East Anglia ONE North and East Anglia TWO Offshore Windfarms

Applicants' Comments SASES Deadline 8 Submissions

Applicant: East Anglia TWO and East Anglia ONE North Limited
Document Reference: ExA.AS-9.D9.V1
SPR Reference: EA1N_EA2-DWF-ENV-REP-IBR-001038

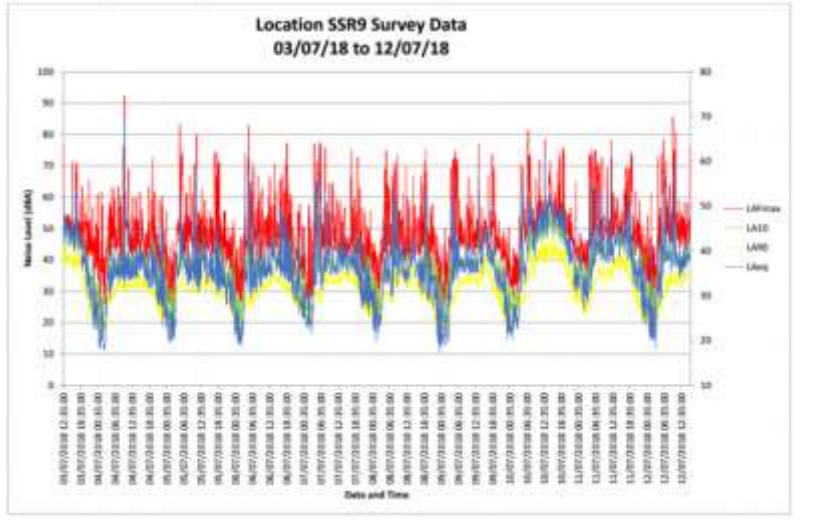
ID	SASES' Comment	Applicants' Comments
<p>Applicants ESC and SASES to provide final written positions explaining their technical position in relation to the assessment method and approach to background noise levels, reasons for the apparent differences of view and evidence in the technical literature upon which each view is based.</p>		
10	<p>The applicants appear now to accept that the night time background levels in the Friston area are low, although Colin Cobbing qualified this acceptance orally at ISH12 by saying that the very low noise levels occur in the middle of the night, citing the commentary on 8.1 “General” in BS 4142 which states “Among other considerations, diurnal patterns can have a major influence on background sound levels and, for example, the middle of the night can be distinctly different (and potentially of lesser importance) compared to the start or end of the night-time period for sleep purposes. Furthermore, in this general context it can also be necessary to separately assess weekends and weekday periods”. However, while the diurnal patterns from the measurement survey are not reproduced in the ES, they can be found in the PEIR, and at the particularly quiet location SSR9 the lowest levels can be seen to occur just after midnight, and the background drops to low levels before midnight which for people who are not particularly early retirers is the start of the night time period rather than the middle of the night.</p>	<p>Matters relating to background sound levels are addressed further in the Applicants' Position Statement on Noise submitted at Deadline 8 (REP8-039).</p>
